Work Order ID 89728

Item Name: Lug

DRAWING NO. D3394	TITLE LUG	REV. B	<b>DART AEROSPACE LTD ENGINEERING ORDER</b>		D.E.O. NO. D3394-B-1	SHEET NO. SHEET 1 OF 1	SCALE NTS
DRAWN AJS	CHECKED	MFG. APPR.	APPROVED		DE APPR.		
DATE 09.11.04	DATE 09.11.04	DATE 09.11.04	DATE 09.11.04		DATE 09.11.04

DRAWING NO. D3394	TITLE LUG	REV. B	DART AEROSPACE USA, INC ENGINEERING ORDER		D.E.O. NO. D3394-B-2	SHEET NO. SHEET 1 OF 1	SCALE NTS
DRAWN <i>qp</i>	CHECKED <i>Sc</i>	MFG. APPR. <i>M</i>	APPROVED <i>NP</i>		DE APPR. <i>H</i>		
DATE 11.05.02	DATE 11.05.09	DATE 11.05.08	DATE 11.05.08		DATE 11.05.09

SHEET 4 ZONE A,1 MODIFY SECTION A-A AS SHOWN:

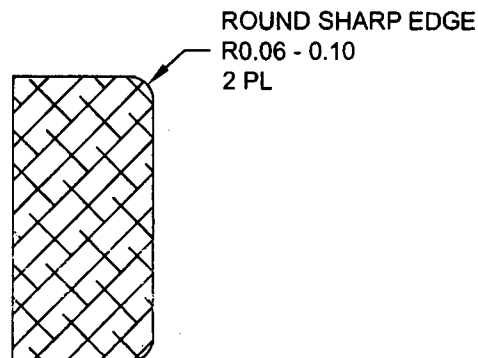
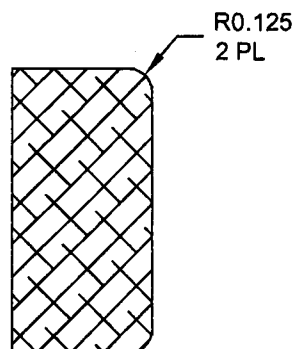
REASON: DRAFTING ERROR

D3394-1RG LUG (SHOWN)  
D3394-3RG/-5RG LUGS (SIMILAR)  
D3394-041RG/-043RG/-045RG LUG ASSEMBLIES (SIMILAR)

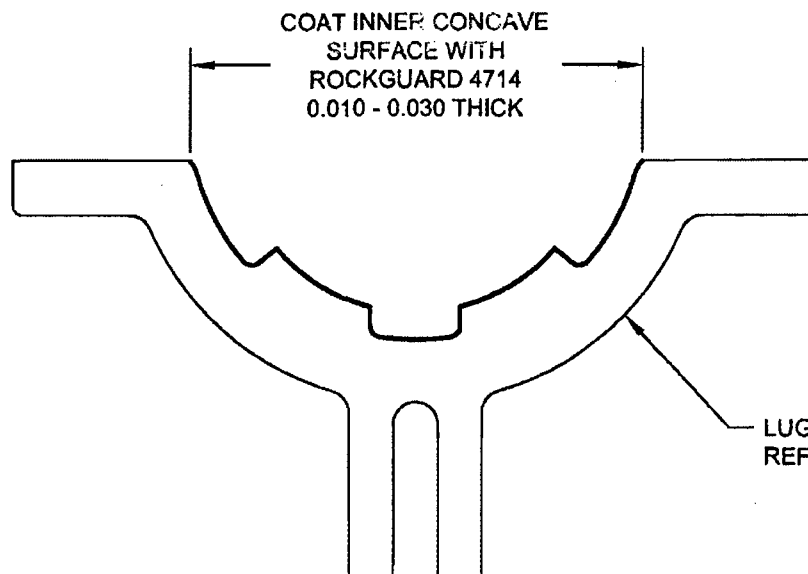
ADD D3394-xRG OPTION

D3394-xRG MOUNTING LUGS ARE INDENTICAL TO D3394-x MOUNTING LUGS, HOWEVER AFTER FINISH, COAT INNER CONCAVE SURFACE WITH "PLUS ONE ROCKGUARD 4714" AS SHOWN BELOW.
